Resolution No. 22, “SIGNI - Signs and Signals on Inland Waterways”

Amendments to Resolution No. 22

Note by the secretariat

Additions and amendments to Resolution No. 22 on SIGNI: Signs and Signals on Inland Waterways

2.1.2 Left-hand side of the fairway

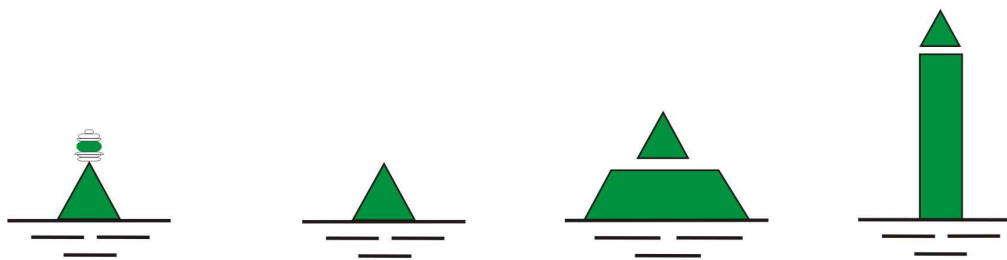
(b) Amend section 2.1.2, “Left-hand side of the fairway” as follows:

Colour: green

Form: conical buoy or buoy with a topmark, or spar

Topmark (if any): green cone, point upwards

Light (when fitted): rhythmic green light

2.1.3 Bifurcation of the fairway

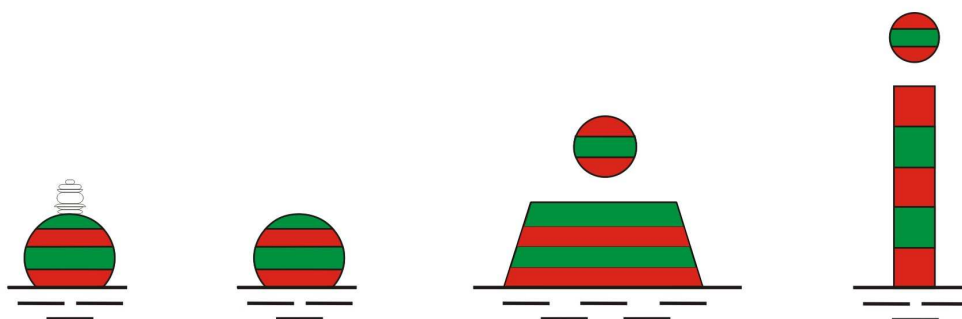
(c) Amend the section 2.1.3, “Bifurcation of the fairway” as follows:

Colour: horizontal red and green bands

Form: spherical buoy or buoy with a topmark, or spar

Topmark (if any): sphere with horizontal red and green bands

Light (when fitted): continuous scintillating white light, or isophase white light (may be the group-flashing white light with a group of three flashes)

Where there is a risk of confusion with maritime signs and signals or with signs and signals for lakes and broad waterways as defined in 2.4, the above-mentioned rhythm of light shall not be used and shall be replaced by the group-flashing rhythm (group of three flashes).

(fig. 4)

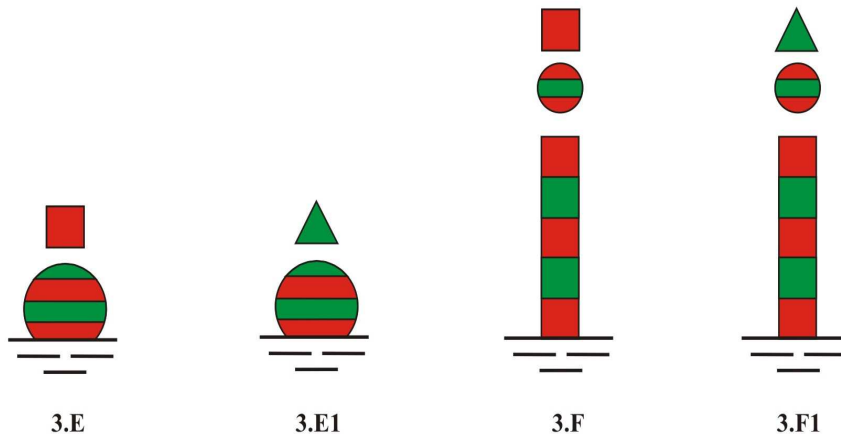
Where necessary, a red cylindrical topmark or green conical topmark placed above the bifurcation mark indicates on which side it is preferable to pass (main fairway).

The mark shall then bear a rhythmic red light or a rhythmic green light, as appropriate.

(fig. 7)

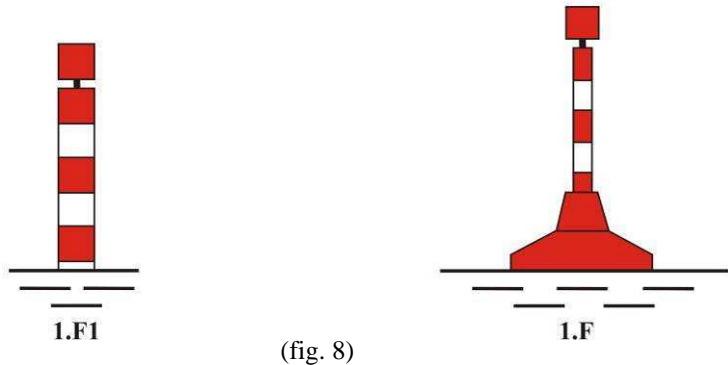
3. Bifurcation

Colour: red/green

Form: post with topmark

Topmark: red cone, point downwards, above a green cone, point upwards

Light (when fitted): continuous scintillating white light or isophase white light (may be the group-flashing white light with a group of three flashes)

The above cones may be replaced by triangular panels with a white background and a red or green border.

2.4.3.2 Description of isolated danger marks

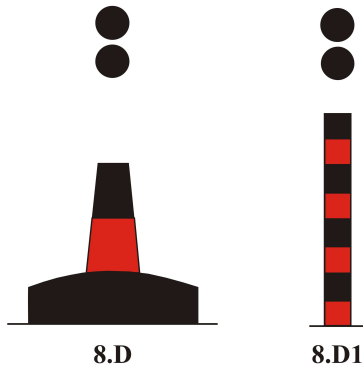
(c) Amend paragraph 2.4.3.2 “Description of isolated danger marks” as follows:

Colour : black with one or more broad horizontal
 Form : any (generally pillar or spar) with topmark
 Topmark : two black spheres, one above the other
 Light (when fitted):
 Colour : white
 Rhythm : group flashing (group of two flashes)

2.4.4.2 Description of safe water marks

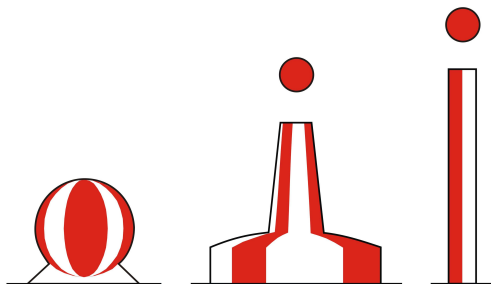
(d) Amend paragraph 2.4.4.2 “Description of safe water marks” as follows:

Colour : red and white vertical stripes
 Form : spherical buoy or pillar or spar with topmark
 Topmark (if any) : single red sphere
 Light (when fitted):
 Colour : white
 Rhythm : isophase, single-occluding, one long flash every 10 seconds or Morse code "A"
